ADDENDUM NO. 1

DATE: March 21, 2023

PROJECT: O'PLAINE ROAD WATER MAIN REPLACEMENT

OWNER: VILLAGE OF GURNEE

SUMMARY OF QUANTITIES

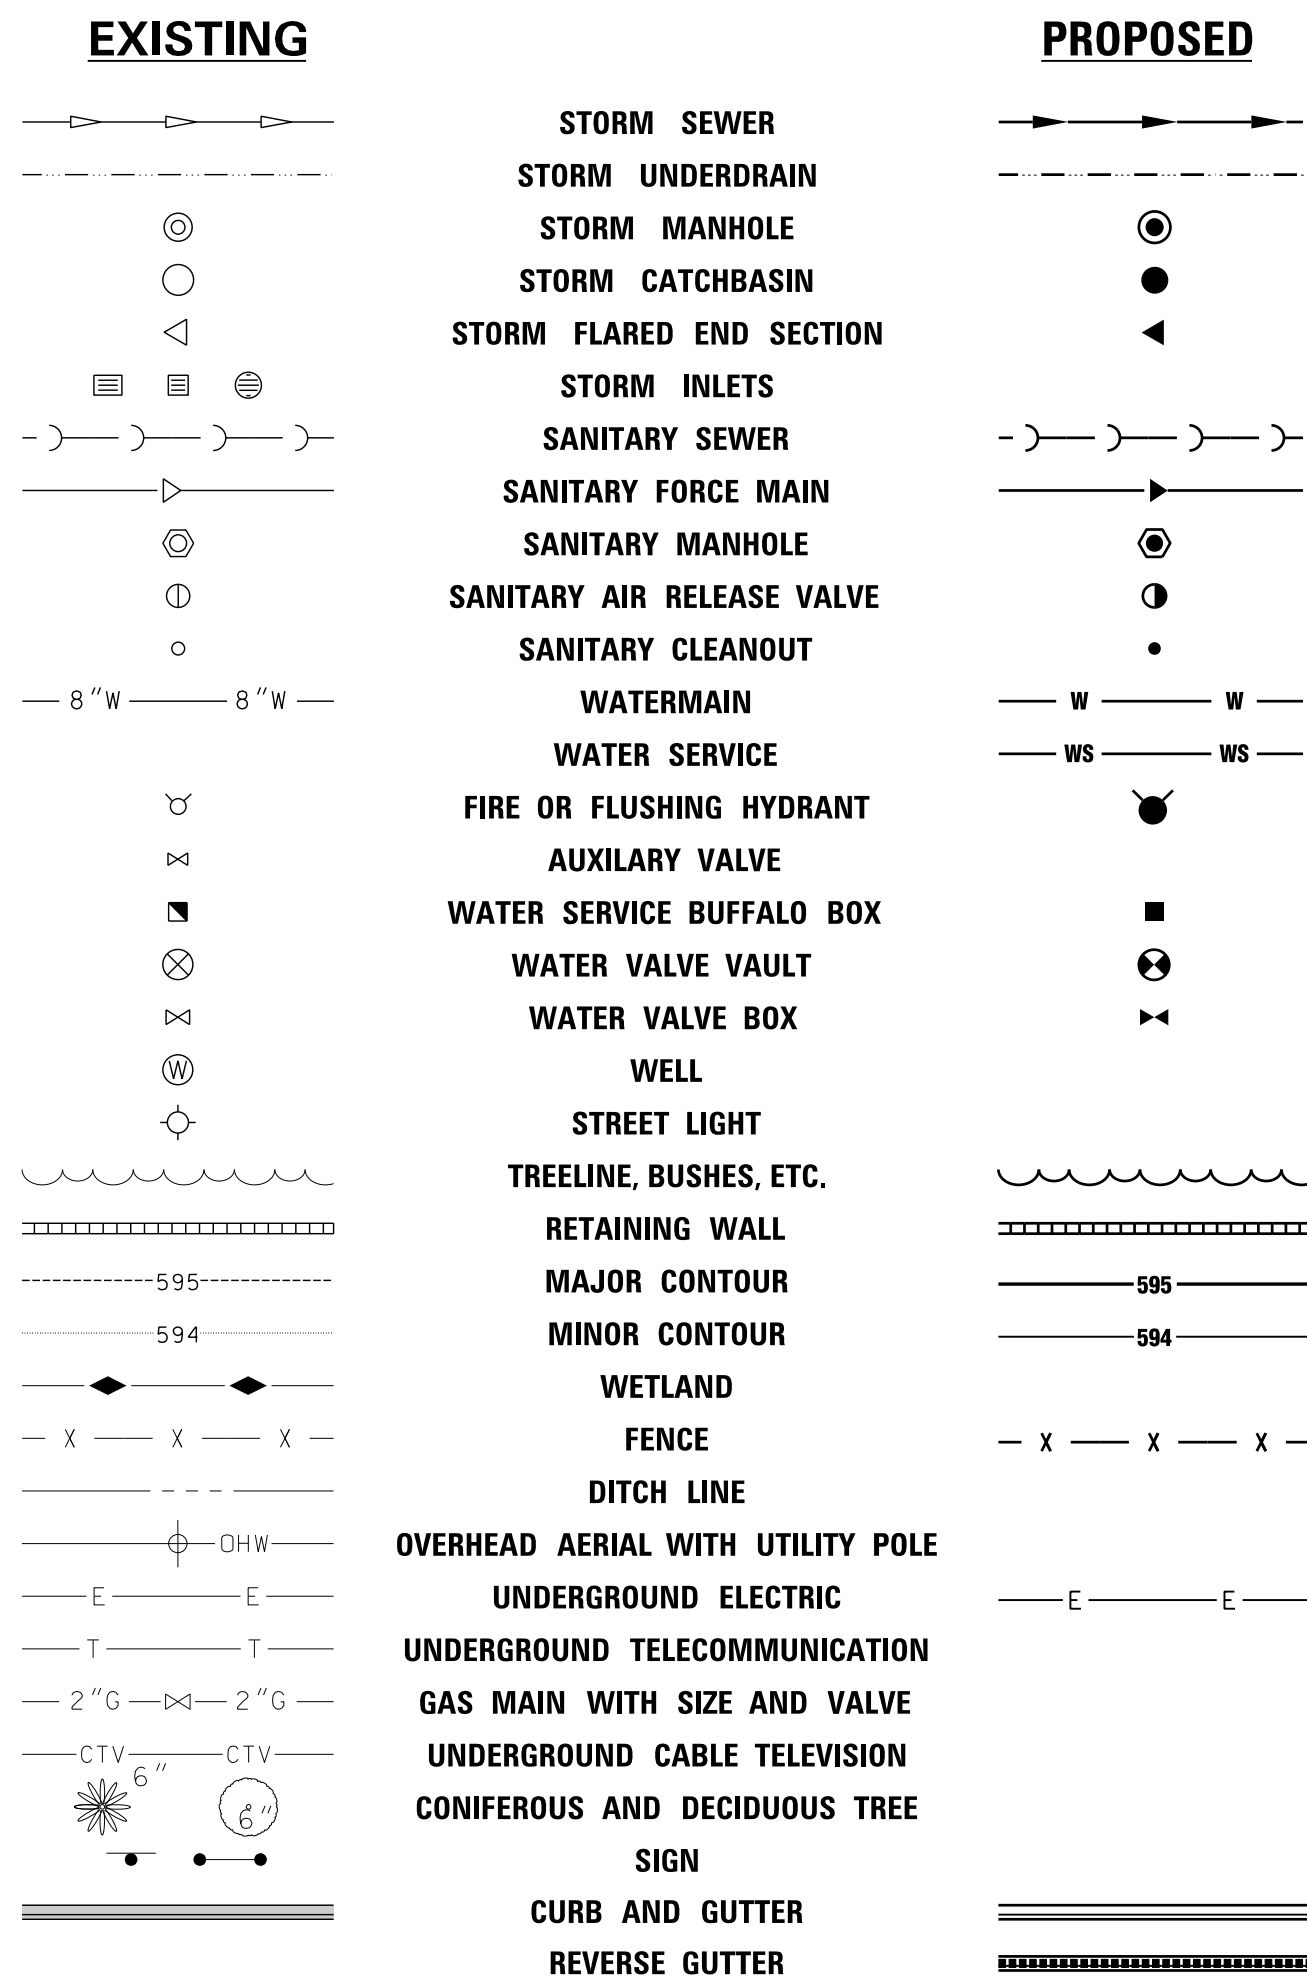
- a. Replace Sheets BF 14 & BF 15 of the Project Manual with Pages 5 & 6 of this addenda. Item Number 36, TREE REMOVAL, OVER 15" – 25.2 UNITS is removed from the contract.
- b. The "TREE REMOVAL, 25.2 UNITS DIA." Note on SHEET 5 of the plans can be disregarded.
